Wayland Union Schools  
850 E. Superior Street  
Wayland, MI 49348

REQUEST FOR PROPOSALS  
For  
High School Gymnasium Floor (0311-21)  
Addendum No 1

## 4" VOLLEYBALL FLOOR SLEEVE & COVER INSTALLED

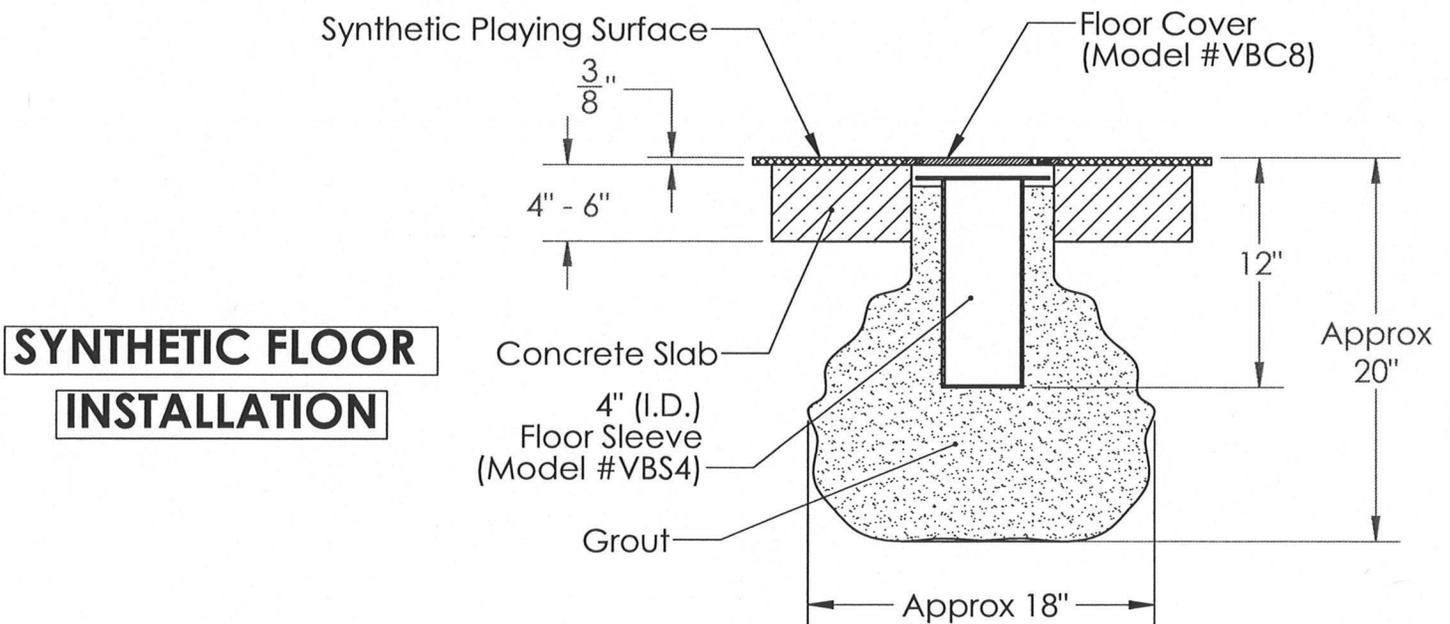
**Project Addition:** 11. The district intends to purchase six (6) Schelde Sports 4” Floor Sleeves and Brass covers for three (3) volleyball court setups. Awarded vendor must prepare the new floor below grade, at grade, and at floor level, floor must be prepped to accept the floor sleeves and brass covers as spec’d by Schelde Sports and installed (sleeves and brass provided by the district) by the vendor who is awarded the RFP. Please see Schelde Sports’ shop drawing (Exhibit C and D) as provided for RFP pricing. Location to be where current pole sleeves are located.
